```
1020 N. E. Loop 410, Suite 700
  San Antonio, TX 78209
  Ph: (210) 824-6044 Fax: (210) 824-7656
                                                                      RFI
    To: Trent Perkins
                                                                             RFI #: 25
            Parkin Perkins Olsen
                                                                             Date: 1/5/2012
            9330 LBJ Freeway, Suite 1055
                                                                             Job: EB-02 Keller Springs Lofts
            Dallas, TX 75243
                                                                           Phone: 877-777-5115
            Ph: (214)221-2220 Fax: (214)221-2252
    Subject: L shaped rebar dowels

Job: EB-02 Keller Springs Lofts

Subject: Detail for leave out, for oil separator

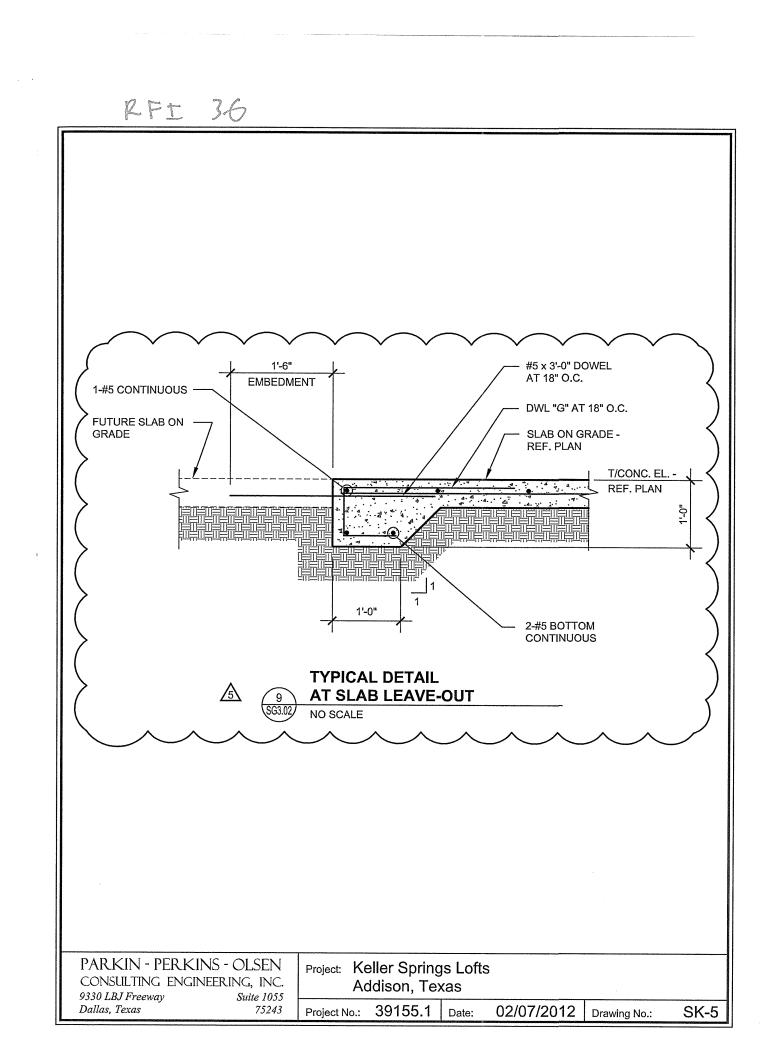
Tent we need to get a detail for a leave on the slab for the two oil separators, please reference RF# 33 which is attached, and the specs for the oil separators.

See Attached.
